ANN ARBOR HISTORIC DISTRICT COMMISSION**Staff Report****ADDRESS:** 514 East Ann Street, Application Number HDC11-089**DISTRICT:** Ann Street Historic Block**REPORT DATE:** July 8, for the July 14, 2011 HDC Meeting**REPORT PREPARED BY:** Jill Thacher, Historic Preservation Coordinator**REVIEW COMMITTEE DATE:** Monday, July 11, 2011

APPLICATION: The applicant seeks HDC approval to move the existing west wall of an attached rear addition two feet to the east in order to make the addition compliant with zoning regulations. The existing roof would not be affected. Two double-hung windows would be installed on the new west wall.

WEST SIDE ELEVATION
1/4" = 1'-0"

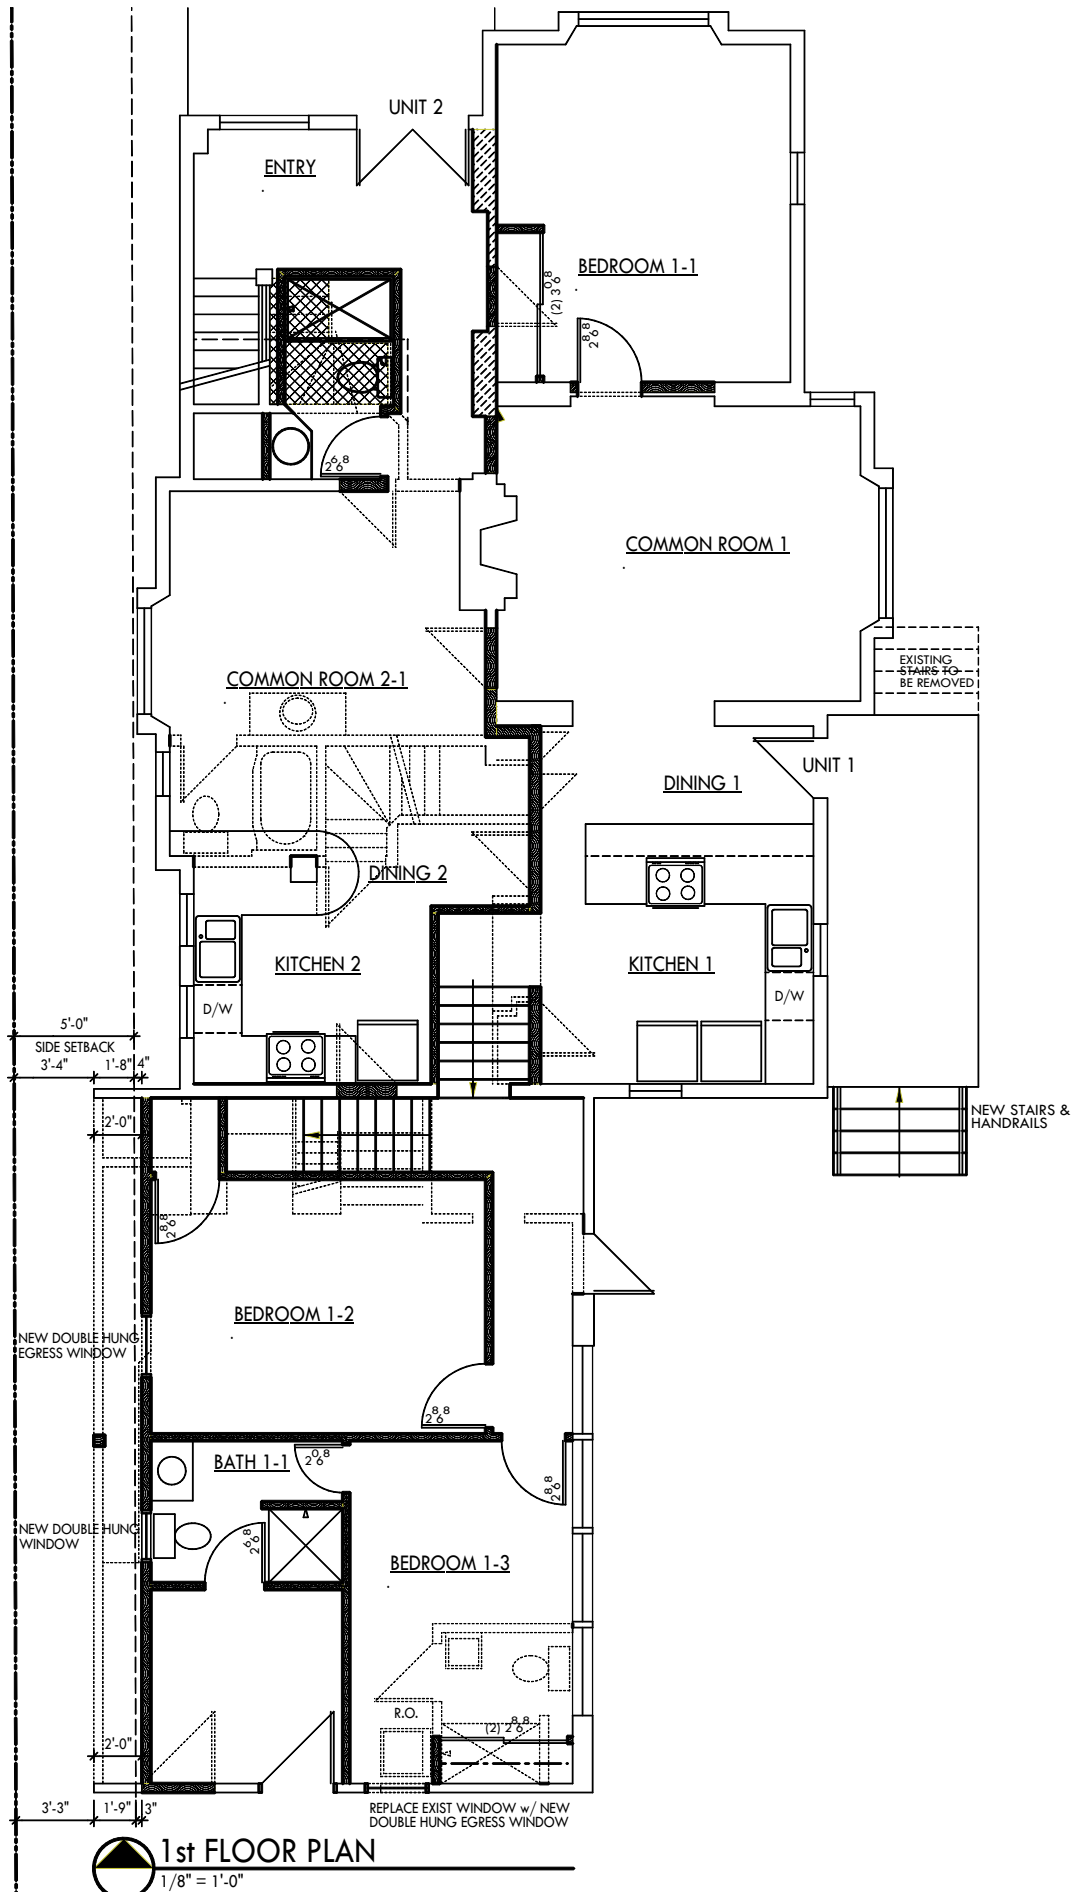
2. This application proposes moving the west wall of the addition two feet in order to comply with building setback regulations. The roof would remain the same, with a two foot eave overhang to the new wall, and full-height end walls mean that the appearance from the front or rear would also remain the same. The proposed double-hung windows are more appropriate than the previously approved casements.

4. Staff believes that the proposed work does not diminish the overall historic character of the property. Staff also suggests that since the owner is structurally altering the rear addition, it would also be appropriate to remove the garage door and install double-hung windows and matching siding in its place, since the addition will no longer be used as a garage. Removing the garage door would be appropriate work to make the addition more compatible with the historic house. Staff is hopeful that the owner will take this suggestion seriously.
